Inconsistent and Missing Drawings

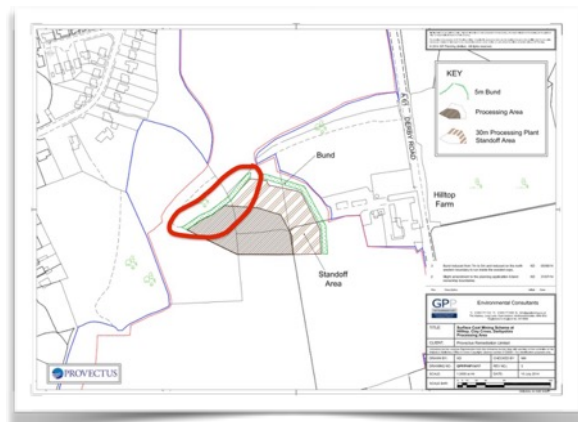
These cross sections do not match the other plans submitted as part of this application. They do not show the position of the various bunds and indicate that the cuts extend to the outer boundaries of the site. Section 1 shows the eastern edge of Cut 7 (?) to be within 2m of the A61 highway.

We must assume that, as these cross sections have been submitted as part of the application, they form the basis other calculations in the submission. Such calculations must therefore be invalid. The position and depth of the cuts will have been used to calculate volumes of overburden to be excavated and moved and also in determining the position and depth of noise sources for the Noise Assessment Report.

Consequently, all other documents must be considered erroneous and inadmissible until such time that revised Cross Sections are submitted. Clarification must then be given about which drawings other calculations and assumptions are based on.
